Access Compliance Report

Public Rights-of-Way

(Curb Ramps)

Intersection ID: 3351	Main Street: FAIRLEA_DR	Cross Street: PROSPERITY_CHURCH_RD	Location: W
ADA ID: 171B41ED6831	Ramp Type: PerpDiag	Initial Pass/Fail: Fail	Overall Compliance: No
Codes/Mitigation Info/Possible Solution		Field Measurements/Component Compliance	
Severity Score: 22.5

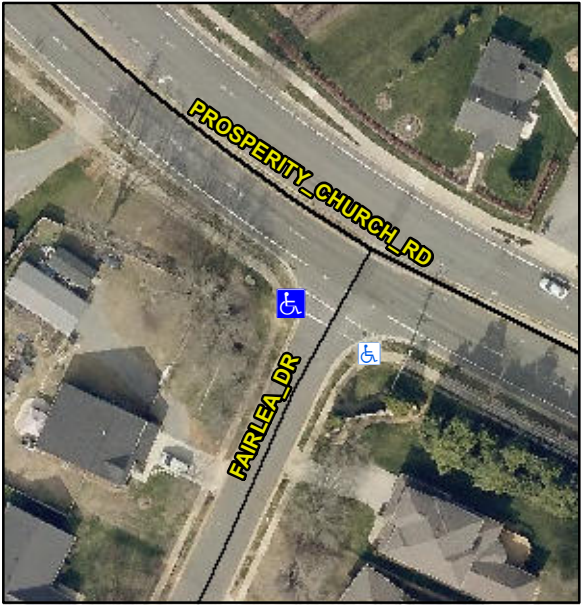
Possible Solutions:	Compliance	Description	Data	Compliance	Description	Data
	Remove & Replace Curb Ramp With Two New Directional Ramps or Equivalent.	N/A	Ramp Length (in)	76.5	No	Ramp Slope (%)	8.5
		No	Ramp Width (in)	39.0	No	Ramp XSlope (%)	4.2
		N/A	Flare Type LT	N/A	N/A	Flare Type RT	N/A
		N/A	Flare Slope LT (%)	N/A	N/A	Flare Slope RT (%)	N/A
		N/A	Flare Traversable LT?	N/A	N/A	Flare Traversable RT?	N/A
		N/A	Landing Length (in)	N/A	N/A	DWS Provided?	N/A
		N/A	Landing Width (in)	N/A	N/A	DWS Contrast?	N/A
		N/A	Landing Slope (%)	N/A	N/A	DWS Length (in)	N/A
		N/A	Landing X Slope (%)	N/A	N/A	DWS Full Width?	N/A
<p>Surveyor Notes:</p> <p>N/A</p> <p>PROW/ADA:</p> <p>Not Found, R304.5.1, R304.2.2, R304.5.3</p>		N/A	Landing Curb? (Y/N)	N/A	N/A	DWS Offset (in)	N/A
		N/A	Shared Landing?	N/A			
		N/A	Gutter Ponding?	N/A	N/A	Gutter Slope (%)	N/A
		N/A	Gutter Lip Ht (in)	N/A	N/A	Gutter X Slope (%)	N/A
		N/A	Painted X Walk1?	Yes	N/A	Painted X Walk2?	No

X Walk 1 Direction	To SE		X Walk 2 Direction	To NE
		N/A	X Walk 1 Width (in)	120.0	N/A	X Walk 2 Width (in)	N/A
			X Walk 1 Slope (%)	3.4		X Walk 2 Slope (%)	0.0
			X Walk 1 X Slope (%)	5.0		X Walk 2 X Slope (%)	2.4
		N/A	Ramp inside XWalk1?	Yes	N/A	Ramp inside XWalk2?	N/A
<p>Street 1 Name</p> <p>Stop Condition-Street 2</p> <p>Street 2 Name</p> <p>Stop Condition-Street 1</p>			Road Slope (%)	3.3	N/A	Clear Space?	N/A
			Road X Slope (%)	4.9	N/A	Clear Space to XWalk (in)	N/A
		N/A	Any Obstructions?	N/A	N/A	Storm Grate/Utility Hazard?	N/A
			Obstruction Type			Storm Grate/Utility Type	
					N/A		N/A
					Yes	Surface Condition? (G/P)	Good
Total Cost:		\$	3200.00
